DRAINAGE INFORMATION SHEET

RE: DRAINAGE PLAN FOR NATIONAL FOREST SERVICE
& ANIMAL DAMAGE CONTROL (E-16/D3C)
ENGINEER'S STAMP DATED JUNE 21, 1989

DRAINAGE PLAN
SHEET NO. 3
JOB NO.: 89-119 OF 15

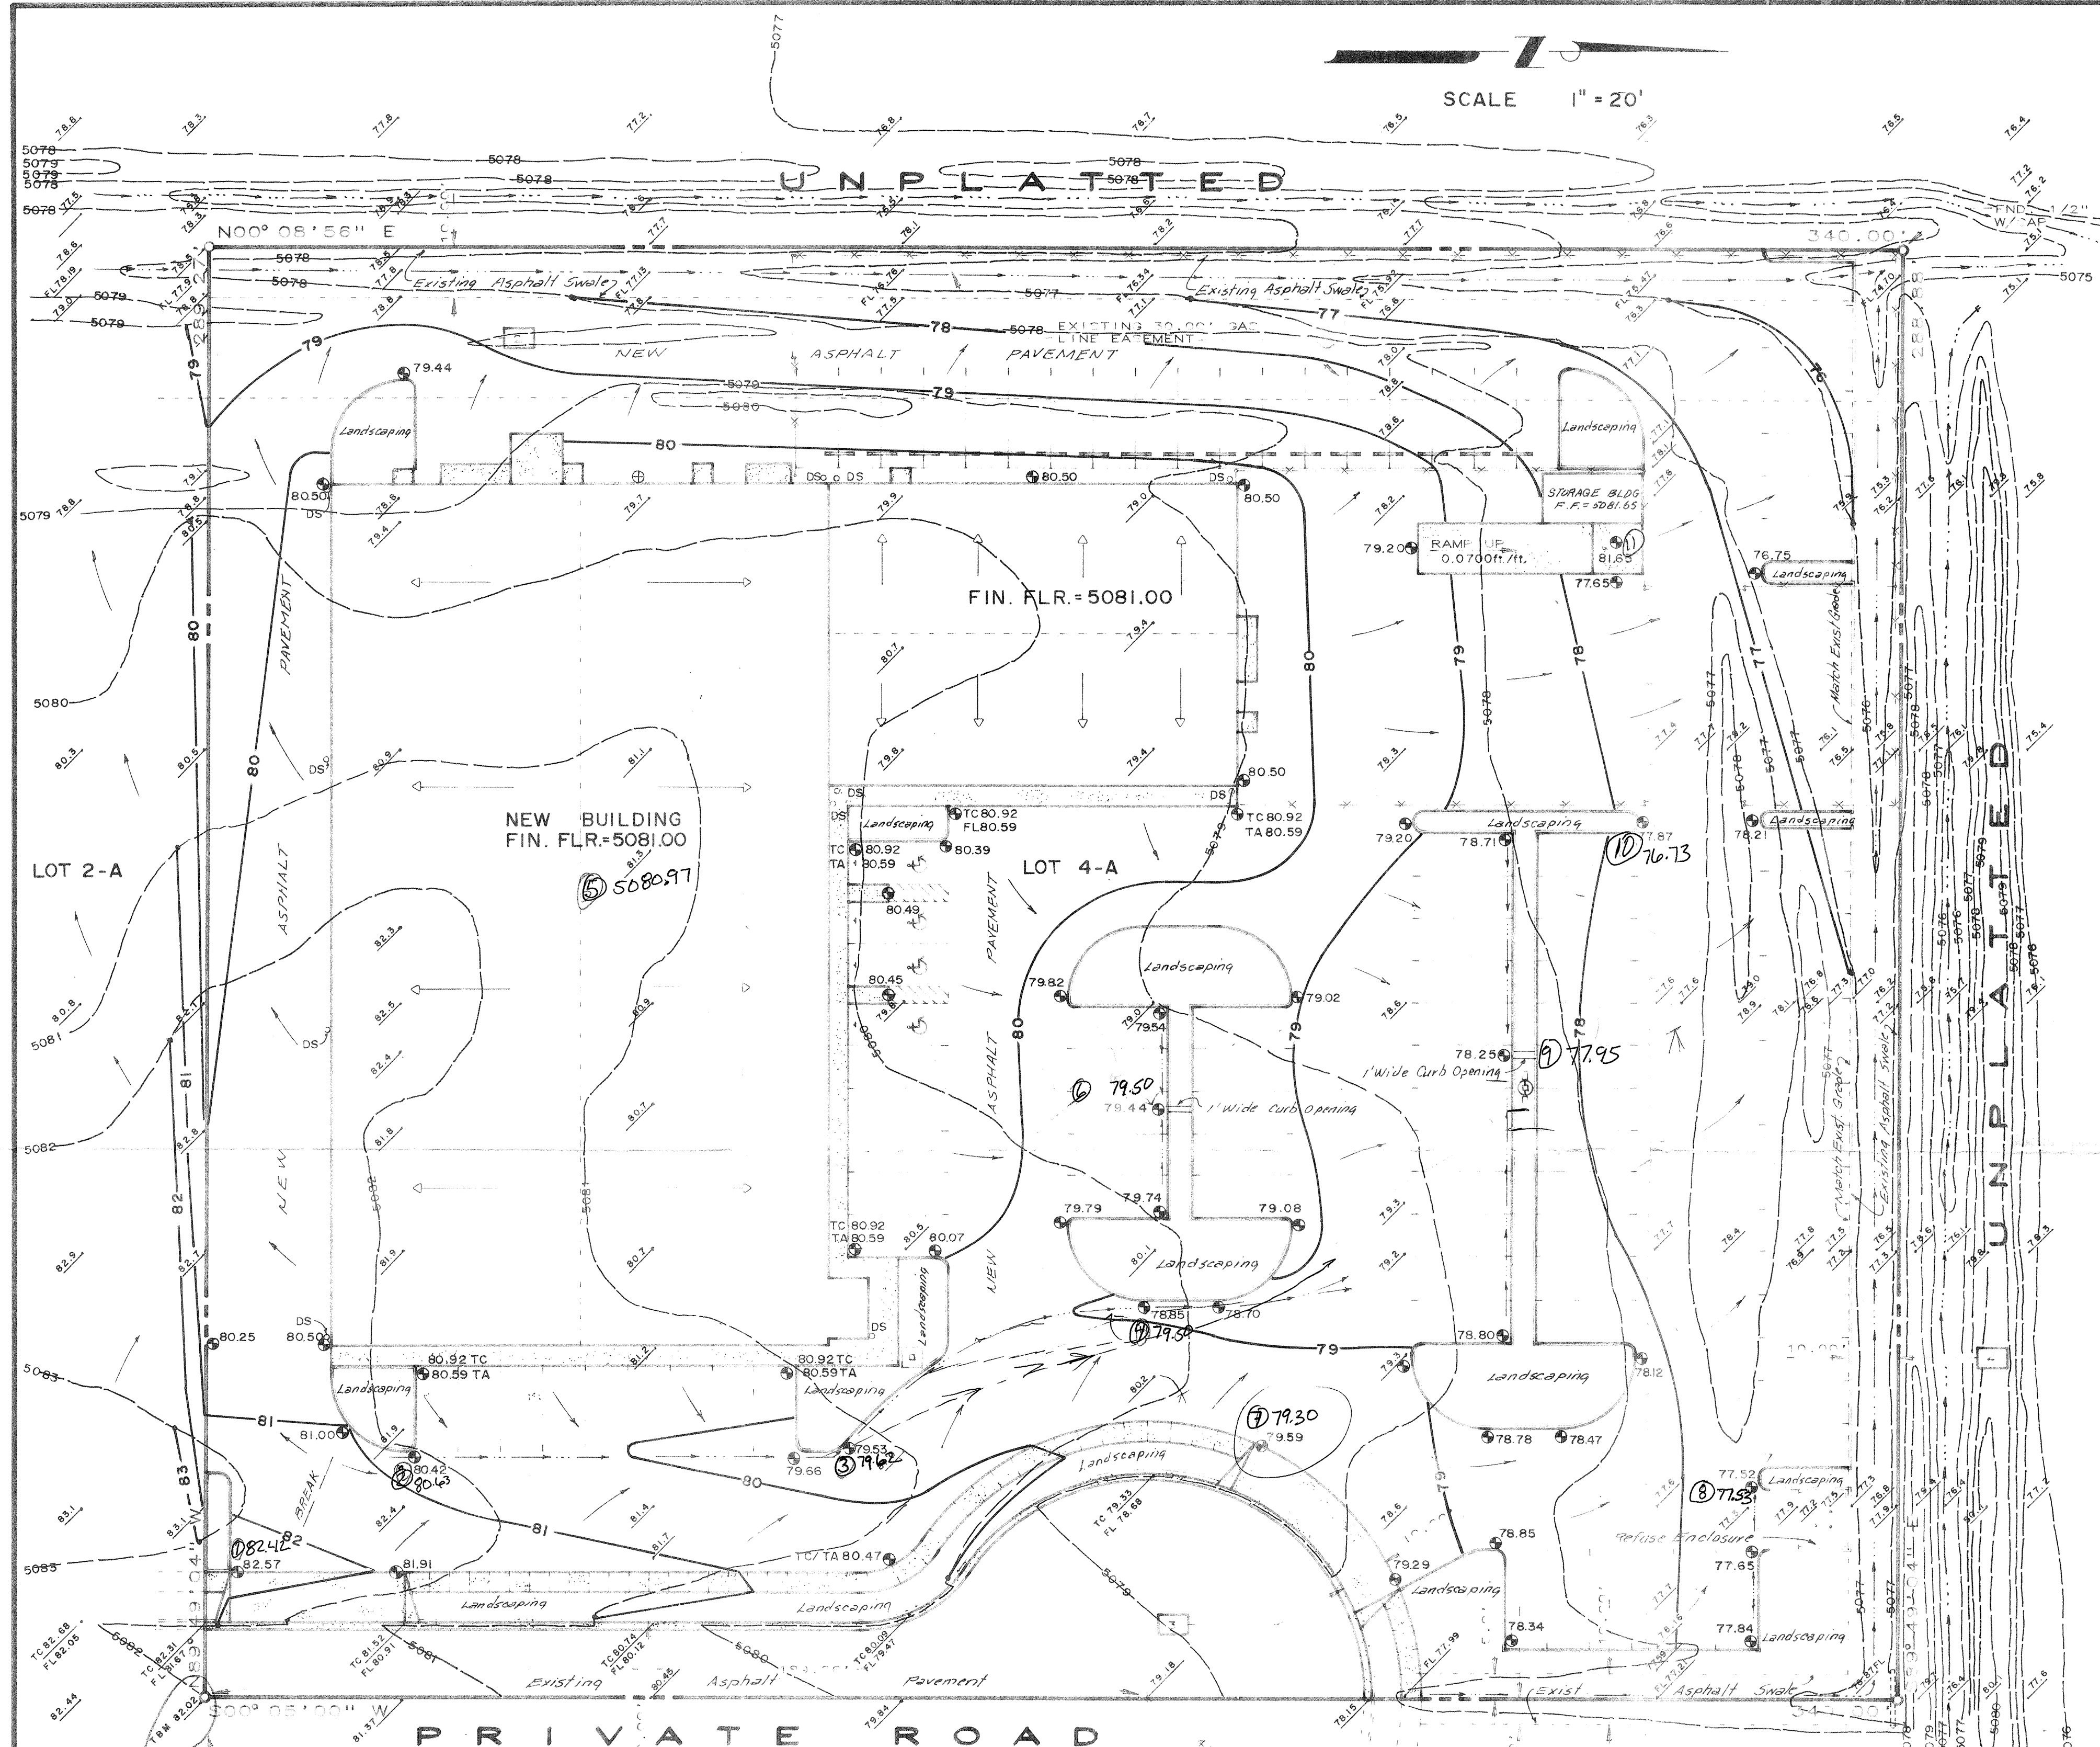
Your submittal indicates that there will be some off-site grading done on the south side of the site. Before the building permit is released, we will need concurrence from the adjacent property owner

Please attach a copy of this plan to the construction sets prior to sign-off by Hydrology.
